Woodstock Quarries Ltd
Attention Darryn Shepherd
12 May 2022

Woodstock Quarry RFI - response to geological questions (Revised)¹

Woodstock Quarry – Updated Pit Slope Design

Figure 1: Woodstock Quarry pit slope design concept for south-facing rock slopes

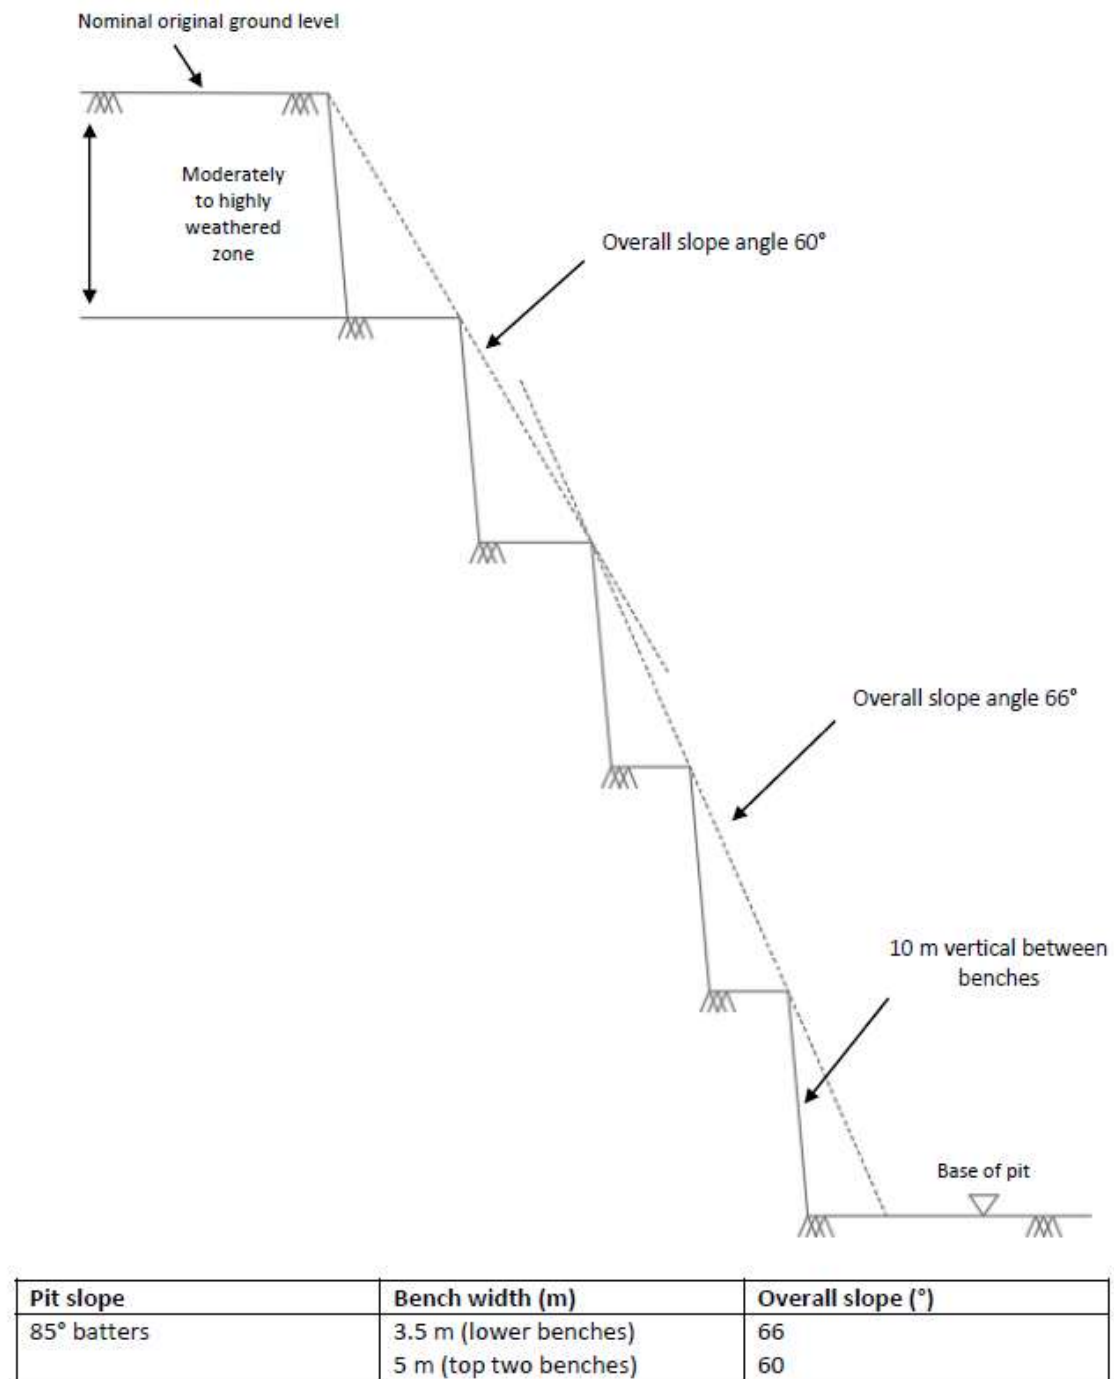
Q23 Overall, considering the above points, the applicant should either reconsider or further justify the proposed cut slope profile, particularly with respect to the design cut slope angles and 2 m inter-bench width to ensure consistency with the geological defect orientations, the adequacy of the proposed bench width and its ability to control rockfall from a safety perspective.

The geology reporting highlights the risk of rockfall both small and large scale. Please provide further clarification on how this will be managed in terms of landfill worker safety, overall slope stability, adopted benching profiles and protection of the landfill liner.

Weathered rock is located above the hard greywacke rock, however proposed excavation profiles do not appear to take into consideration this weather rock with the same 10 m high 2 m width benching profiles adopted. Please provide technical justification and analyse for this design.

Response: Based on the above helpful comments and suggestions, the slope design has been reconfigured to improve safety. The revised proposed design is provided as an attachment. The design philosophy, as noted on the drawing, is

- 10m vertical separation between benches
- Bench widths of 2m and 5m (alternating)
- 5m wide bench within weathered zone (exact base of weathering unknown and expected to vary)
- Overall slope angle ~70°

For the north wall (south, southeast and southwest facing slopes) the interbench batters are proposed to be cut at 85°, and for the east-facing slopes (west wall and temporary faces) 75° batters are proposed. For all slopes, the two top benches are planned to be 5m wide, and the lower benches 3.5m. These can be widened during excavation if the conditions encountered require a design change.

Figure 3: Catch bench design charts for 8-bench hard rock quarry to catch (a) 75%, (b) 90% or (c) 95% of rocks. [From Alejano et al (2007) Figure 16]

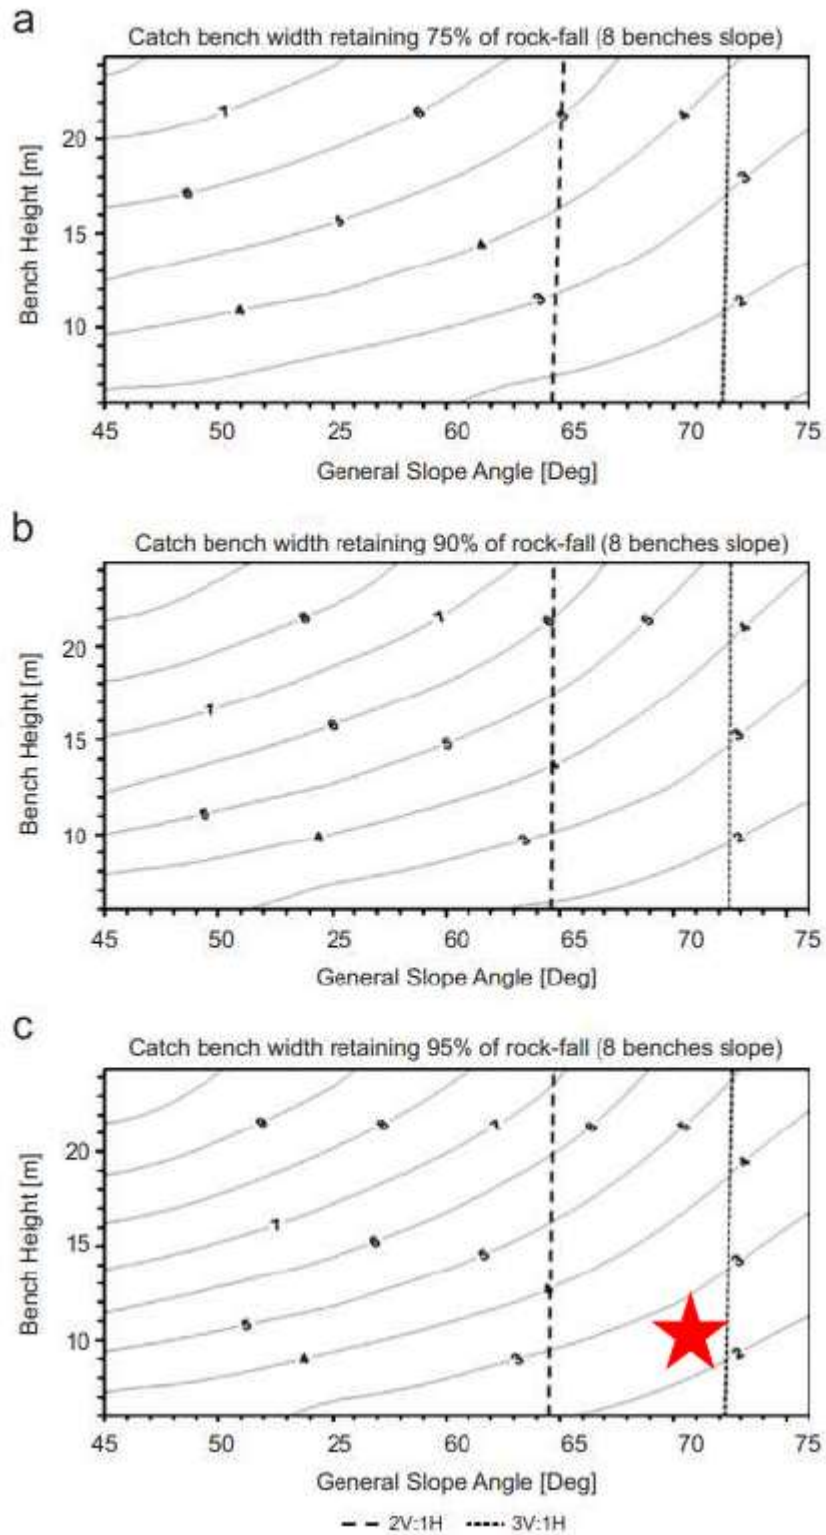
- b. In Section 5.5 of the Geology Report the first paragraph states that the quarry walls will be cut at an unstated angle (presumably dictated by rock defect dip in each wall) with 10 m high inter-bench heights and a 2 m bench. Firstly, this gives an overall angle of 79 degrees which is steeper than the Joint sets J1 and J3 in Table 1 of the Geology report and those shown in Figure 6. Depending on wall vs Joint orientation rock blocks underlain by J1 and J3 will daylight in the proposed cut face and are likely to be unstable as indicated in Appendix C. This could lead to local cut slope failure and represent a danger of rockfall to site staff. Has this risk been considered in the selection of bench width design?

The proposed 3.5m bench width is based on design charts developed by Alejano et al (2007)³. We used the charts for an 8-bench slope as this is the maximum expected in the quarry. As shown by Figure 3, the bench width indicated as necessary to capture 95% of any ongoing rockfall is 2.5m.

For this reason, Alejano et al (2007) further recommend that the bench width should be increased to allow for breakback (partial loss) of the outer edges of the benches and other uncertainties; they suggest this 'backbreak correction' should be 0.5 m for pre-split benches, 1 m for carefully blasted good-quality rock masses, and 2 m for less carefully blasted average-quality rock masses. We have assumed an additional 1m for the Woodstock Quarry benches, making the minimum bench width 3.5m.

1. East-facing slopes:

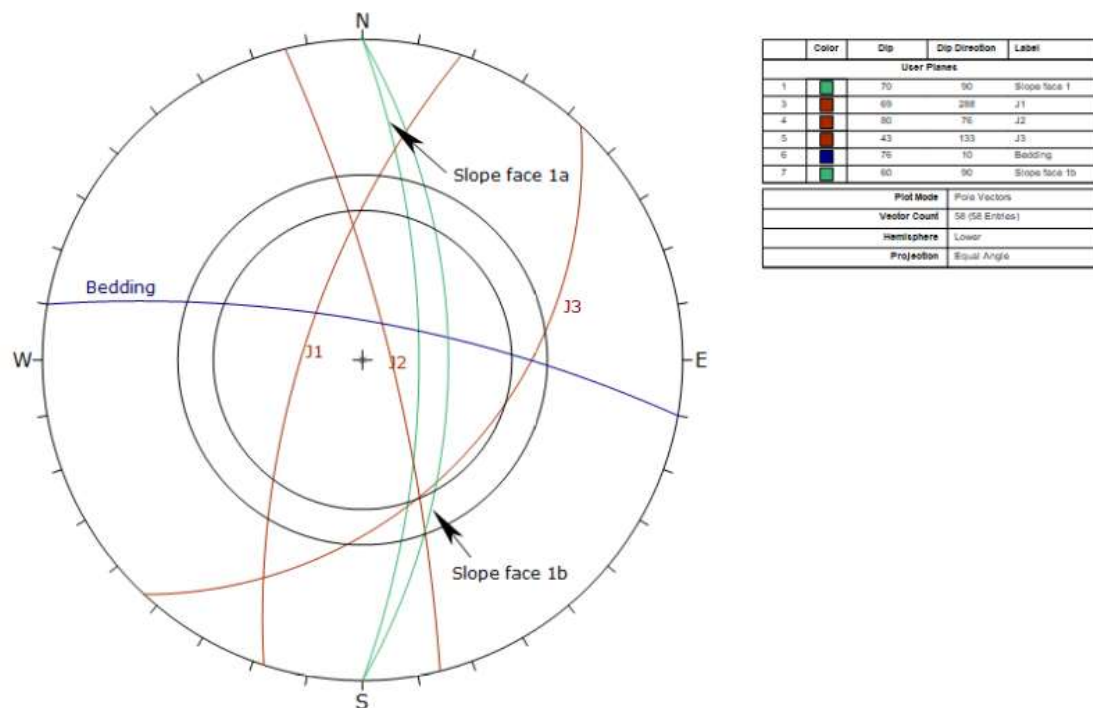
These slopes are formed perpendicular to bedding. Kinematic assessment shows potential for J2/J3 controlled wedge instability in slopes steeper than 60° and for B/J3 wedges in slopes steeper than 30°.

Reducing the slope angle by widening the benches reduces the potential for wedge failures controlled by the J2 and J3 joints. Wedges between J3 joints and bedding remain a potential failure mode for small scale instability of batters.

Proposed overall slope ~60° (75° batters, 3.5m wide benches)

2. South-facing slopes:

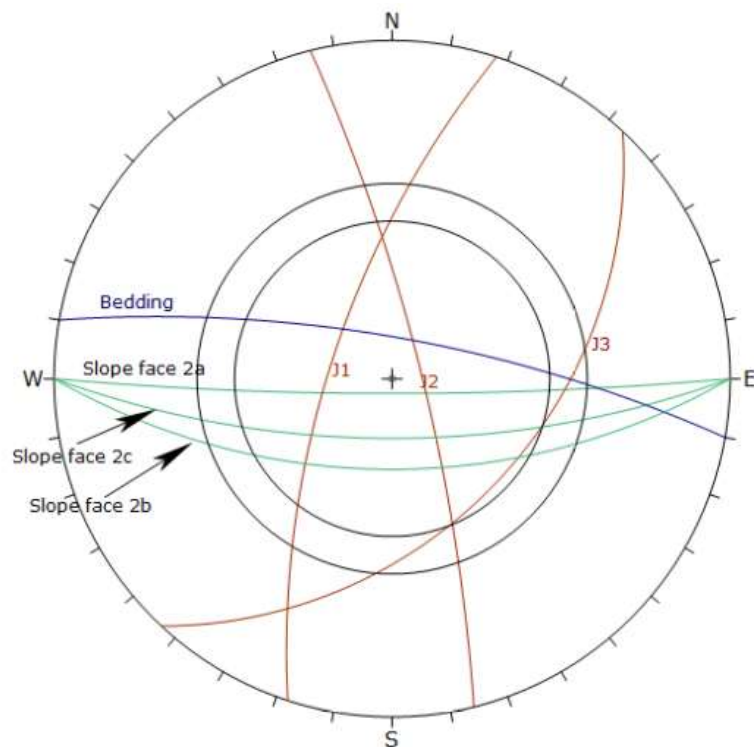
The slopes are formed subparallel to bedding and are expected to be controlled by the bedding planes or bedding plane shears. Toppling from bedding is the dominant potential failure mode. A wedge between joint sets J2 and J3 is feasible. Reducing the slope angle makes no significant difference.

Proposed overall slope ~65° (85° batters, 3.5m wide benches)

3. SE-facing slopes:

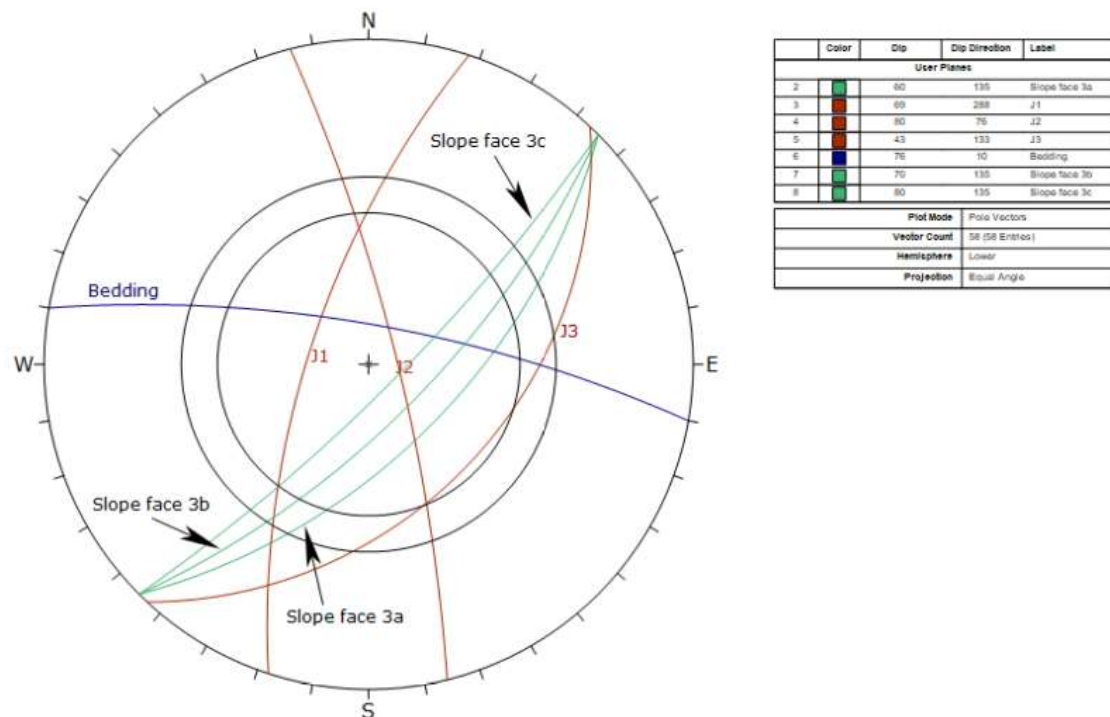
All three slopes show potential for localised wedge failures controlled by joint sets J2 and J3 and potential for planar failures controlled by joint set J3. Wedge topple away from bedding and J1 joints is feasible. Reducing the batter slopes has no significant benefit

Proposed overall slope ~65° (85° batters, 3.5m wide benches)

4. SW-facing slopes

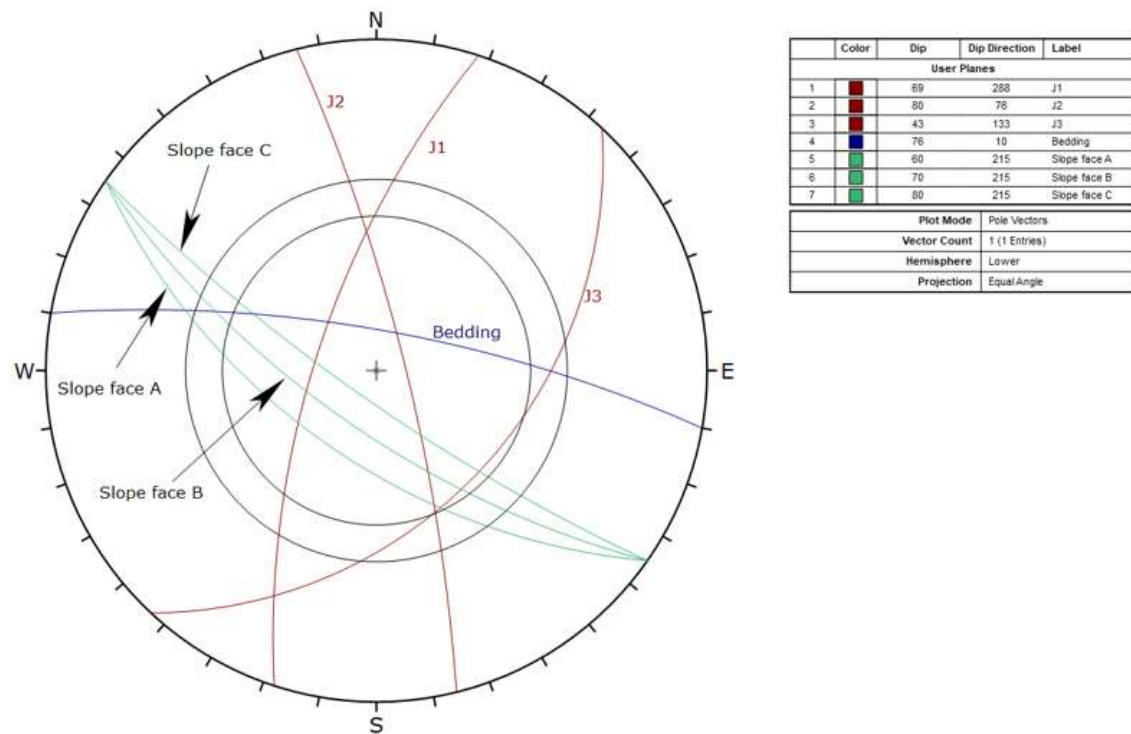
These slopes were not previously assessed. All three slopes show potential for wedge topple failures controlled by (away from) bedding and joint set J2. Bedding strike is more than 20° different from the strike of the face indicating low potential for direct bedding-controlled topple.

Possibly marginal potential for oblique wedge topples controlled by bedding and joint set J1.

Reducing the batter slope angles does not reduce the potential for wedge toppling.

Proposed overall slope ~65° (85° batters, 3.5m wide benches)
